DETAILED ACTION

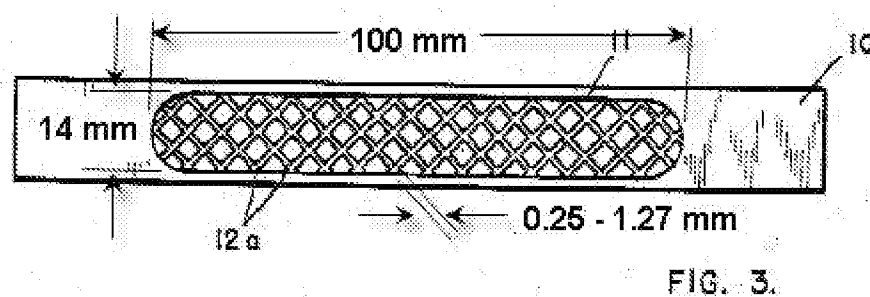
35. Regarding claim 8, Alexander teaches the area ratio occupied by the pattern is at least 30% to the bottom surface area of the cavity with respect to one having a cavity (Col 3, Lines 40-50, see below for pattern to cavity area ratio calculation), or to the upper surface area of the ceramic sintered body with respect to one having no cavity.

The examiners calculation of the ratio of the pattern area to the cavity area is as follows.

The calculations are based on Alexander's dimensional disclosure (Col 3, Lines 40-50 and Fig 3 as shown above).

a. Cavity Area = $(14 \times 100 \text{ mm}) = 1400 \text{ mm}^2$

b. Area of 1 Groove = $(1.27 \text{ mm} \times 14 \text{ mm}) = 17.78 \text{ mm}^2$

The examiner uses 14 mm as the length of the groove, which is conservative because the length of the groove is more than 14 mm because the groove is at an angle.

c. Number of Grooves = 32

d. Pattern Area = Area of 1 Groove x Number of Grooves = $17.78 \times 32 = 568.96$
 mm^2 e. Pattern to Cavity Area Ratio = $(568.96 / 1400) \times 100 = 40.6 \%$
